**LEVY NUCLEAR PLANT, UNITS 1 AND 2  
DOCKET NOS. 52-029 AND 52-030  
SUPPLEMENT 6 TO RESPONSE TO REQUEST FOR ADDITIONAL INFORMATION LETTER NO.  
034 RELATED TO BASIC GEOLOGIC AND SEISMIC INFORMATION**

**Levy Nuclear Plant Units 1 and 2**  
**Supplement 6 to Response to NRC Request for Additional Information Letter No. 034**  
**Related to SRP Section 2.5.1 for the Combined License Application,**  
**Dated May 8, 2009**

**NRC RAI #: 02.05.01-30**

Figure 2.5.1-237 (Revised)

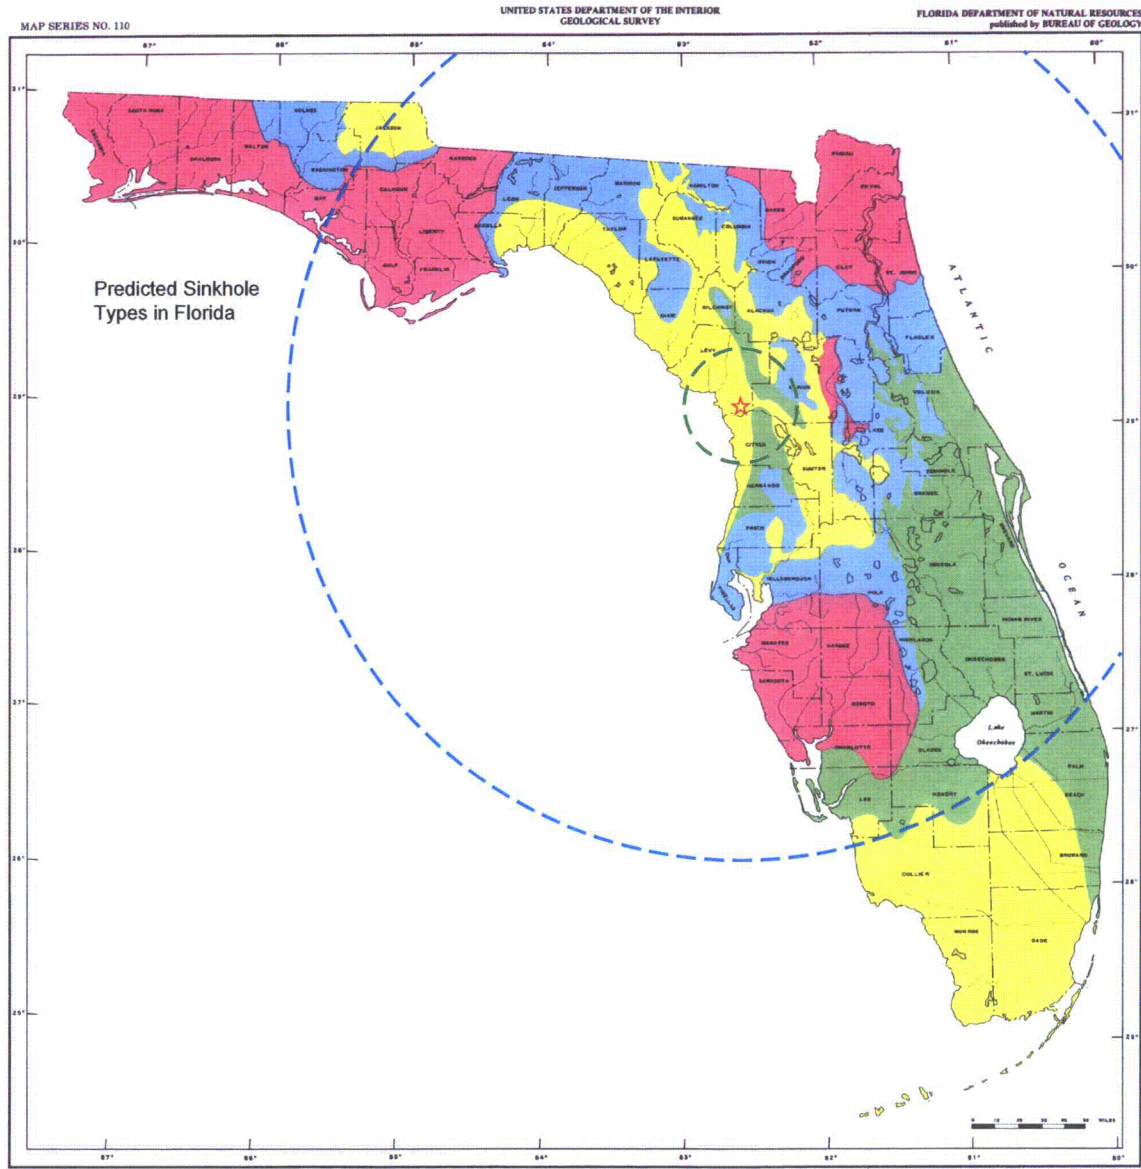
FSAR Section 2.5.1.2.1.3 (pg 2.5-61) states that Figure 2.5.1-237 shows the LNP site is located where sinkholes are few and gradually develop. For sinkhole type, the figure legend indicates that solution sinkholes dominate. However, the inset map in that same figure apparently assesses future sinkhole risk and appears to indicate that a high density of sinkholes could develop at the site, with a moderate intensity of surface collapse possible. There is no quantitative expression of the future risk of sinkhole development at the site.

In order for the staff to assess the risk of future sinkhole development at the site, please discuss information presented in the inset map of Figure 2.5.1-237 in regard to potential implications for increased hazard due to future sinkhole development at the site.

This RAI was previously responded to in NPD-NRC-2009-134 (July 1, 2009). This update is provided to revise the figure title to more accurately describe the contents of the revised figure. A copy of the revised figure is attached and will be incorporated in a future revision of the FSAR.

Figure 2.5.1-237 will be updated in a future revision of the FSAR as follows:

The term "Sinkhole Risk" will be removed from the title (see Attachment 02.05.01-30A). This version of the figure supersedes that submitted with letters NPD-NRC-2009-134 and NPD-NRC-2009-151.
